Addendum #2

Bangor West Microgrid Resiliency Project, New Combined Heat And Power Unit (CHP), Regional Training Institute, 286th North Hildreth Street, Bangor, Maine. DFE Project Number 23SC21-305-D1, BGS Project Number 3279, Bid Number 23-034.

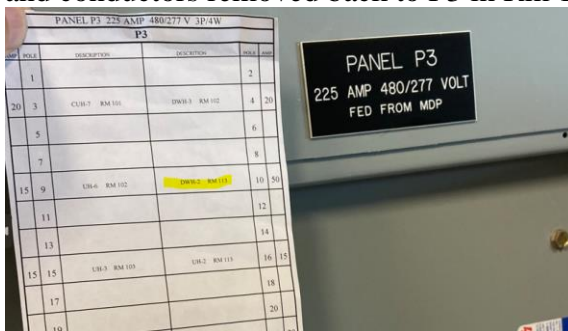
10. **Project Concern:** Will the Onicon meter coming with the CHP have a Bacnet interface through an Onicon System-10 BTU Meter?

Answer: For the sake of the bid, yes. However, modbus is default and since the engine requires Modbus, the DDC system should be Modbus capable.

ATTACHMENT #1

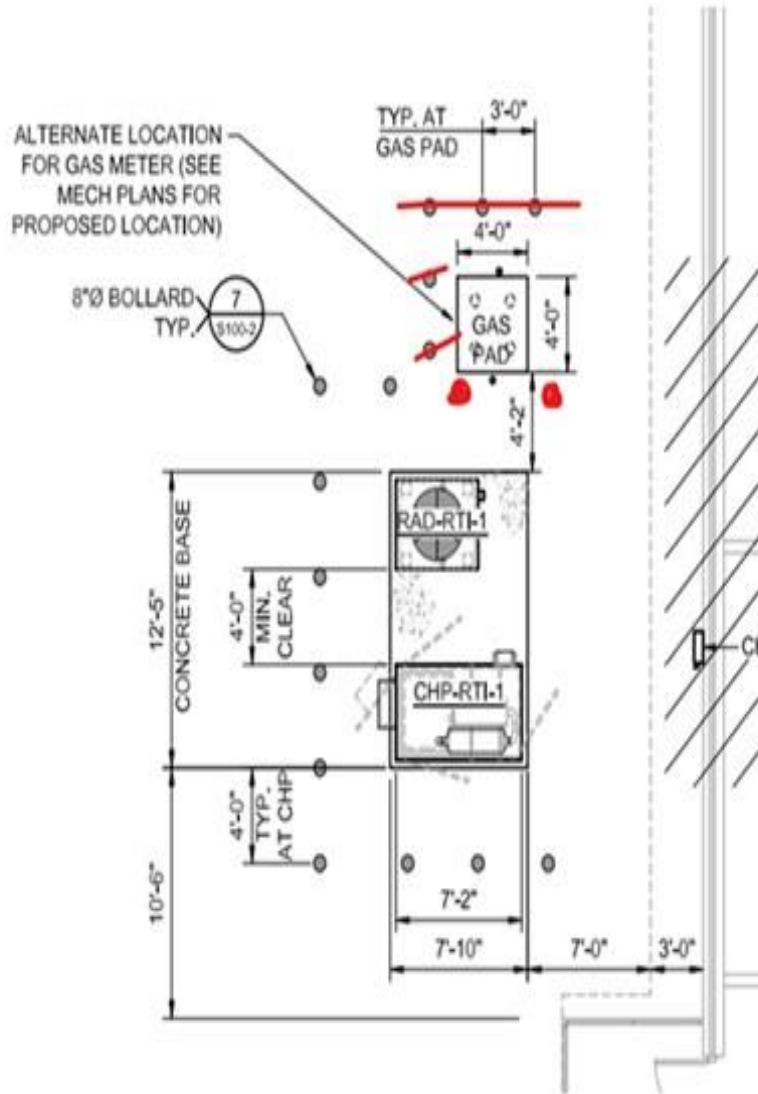
1. **Project Concern:** Addendum #1 deletes the requirement for the new Gas Meter pad. Please clarify the reconfiguration and quantity of bollards protecting the CHP pad now that the gas pad is gone.

There will be 12 bollards protecting the CHP unit. Remove three bollards from your pricing resulting from removal of the gas pad.
